DEPARTMENT OF TRANSPORTATION**National Highway Traffic Safety Administration****49 CFR Parts 561 and 571**

Federal Motor Vehicle Safety Standards; FMVSS No. 305a Electric-Powered Vehicles: Electric Powertrain Integrity Global Technical Regulation No. 20 Incorporation by Reference

ACTION: Final rule.

Figure 1. Voltage Measurements of the High Voltage Source

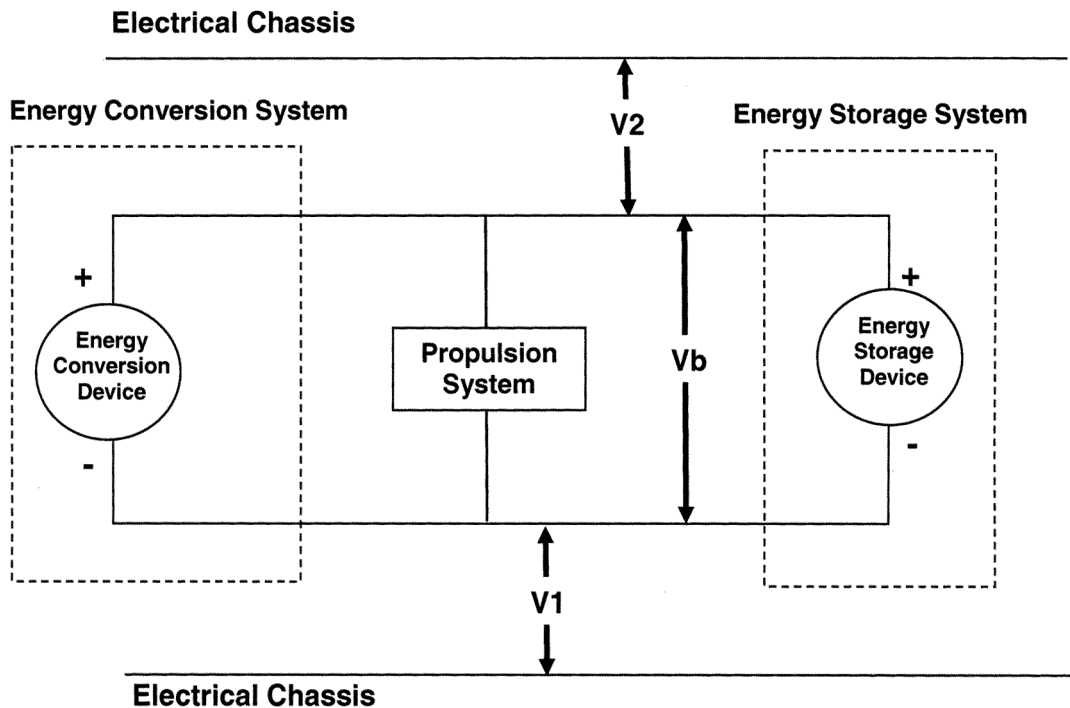
Auto Innovators commented on the proposed calculation method as well, stating, "the NPRM assumes that $V_1 + V_2 = V_{bat}$, but this may not be strictly true," due to multimeter resistance. Auto Innovators provided revised diagrams and formulas and suggested that FMVSS No. 305a provide an electrical isolation compliance option matching ECE 100.03. Bugatti also disagreed with the calculation method for the electrical isolation baseline measurement, saying that it does not address a potential zero-volt measurement across R_o that may occur if R_i is much higher. Bugatti noted that the proposed requirements do not allow the use of a megohmmeter as an alternative method to avoid the zero-volt issue. Bugatti requested clarification and recommended adding the megohmmeter measurement method allowed by ECE 100.03. As with the low energy option for capacitors, Eaton again suggested adding acceptability criteria for battery isolation.

capacitors. After further consideration, the agency agrees that the 60-second time limit is unnecessary for the electrical isolation measurement procedure because the values are static and that harmonization with the GTR No. 20 specification is appropriate. For these reasons, the post-crash test specification has been modified to state that the measurements for the electrical isolation compliance option are made at least 10 seconds after impact, with no upper time limit.

With regard to possible zero-volt measurements in the electrical isolation baseline calculation, the agency does not believe there is an issue. Consistent with GTR No. 20, the minimum resistance of the voltmeter is specified, and a higher resistance R_0 can be used if the voltage measurement is very low. The agency has not observed zero-volt measurements in testing using the specified procedures, which were evaluated for practicability and repeatability. The megohmmeter option from UNECE R100 is not incorporated because research has shown that the megohmmeter method may provide different results than the multimeter method. The agency believes inclusion of the megohmmeter option could lead to inconsistent results and would not be beneficial.

Figure 7b. Jointed Test Finger IPXXB

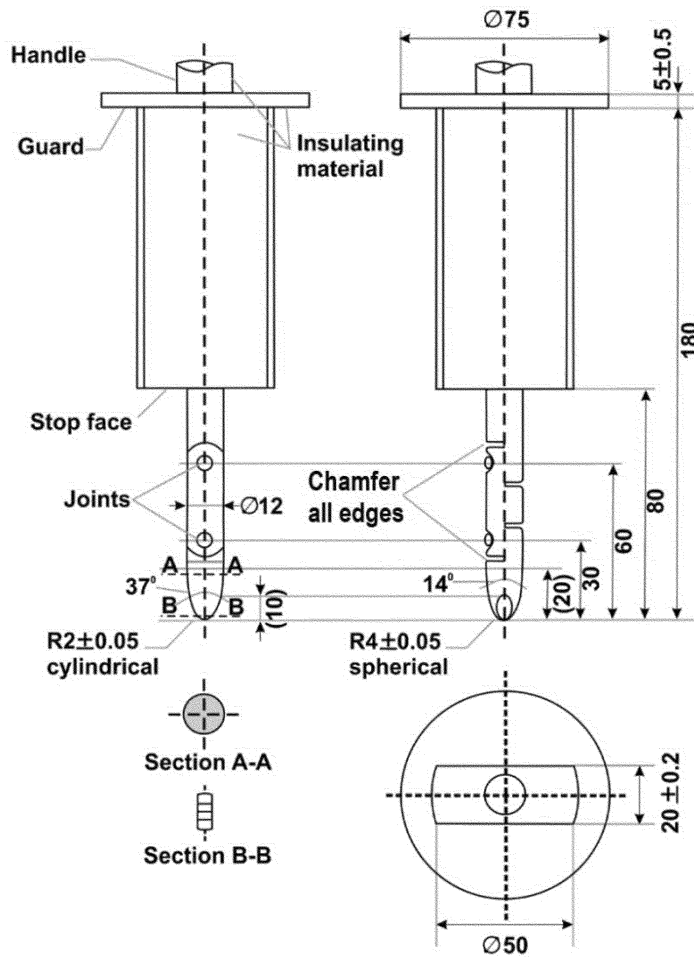
5. *Typographical Error in figure 7b*: EMA requested changing the phrase, “chamber all edges,” to “chamfer all edges,” in figure 7b. Jointed Test Finger IPXXB, of the regulatory text. This final rule corrects the typographical error in figure 7b.
